## Board of Health Agenda

Variance request for for Rasmuson Property

Gardiner Business Park Variance Request

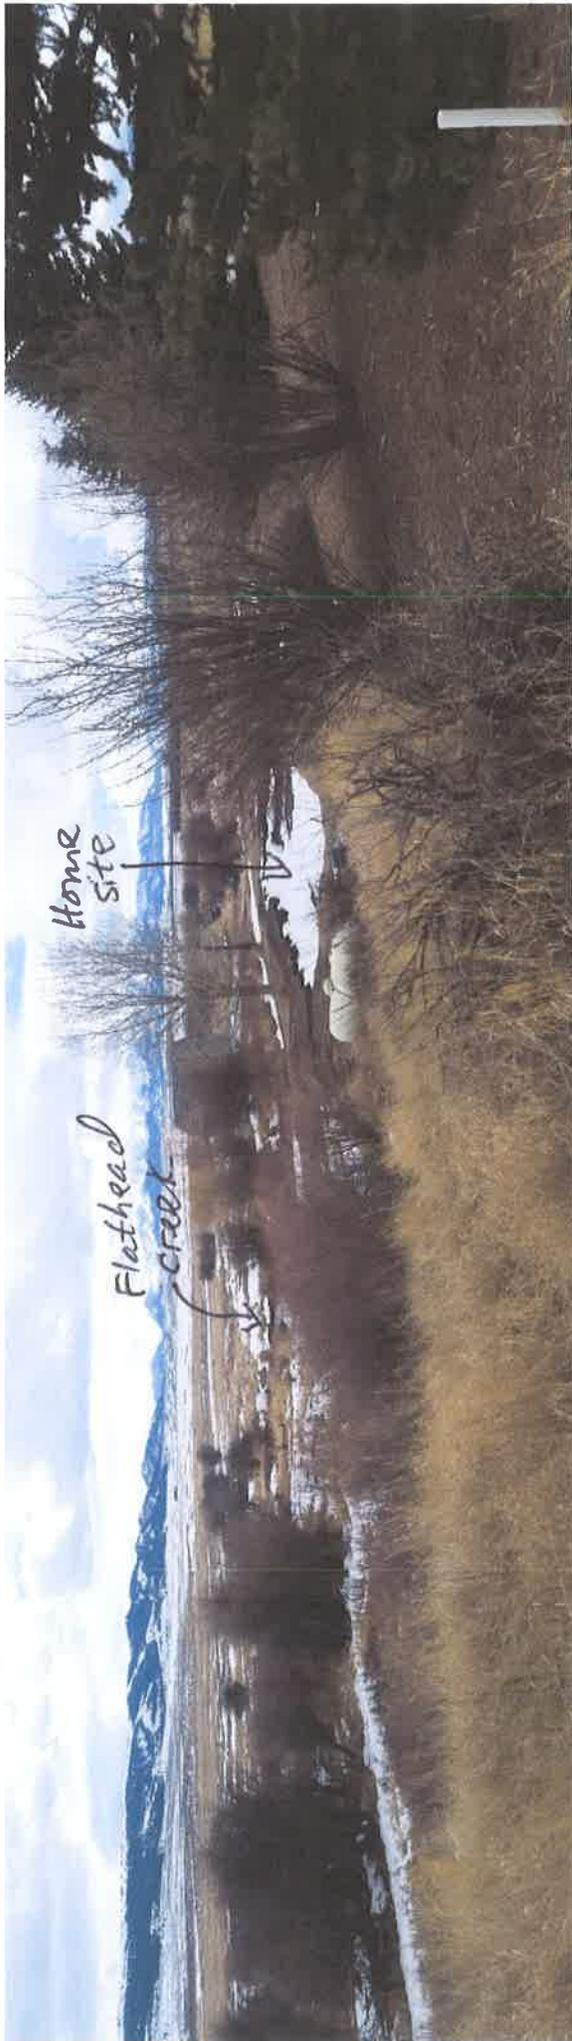
In my opinion, if Flathead Creek were to experience high Flood waters, there is minimal risk involved in regards to water over-topping the proposed drainfield.

Approx Topography of region sloping away from DF location.
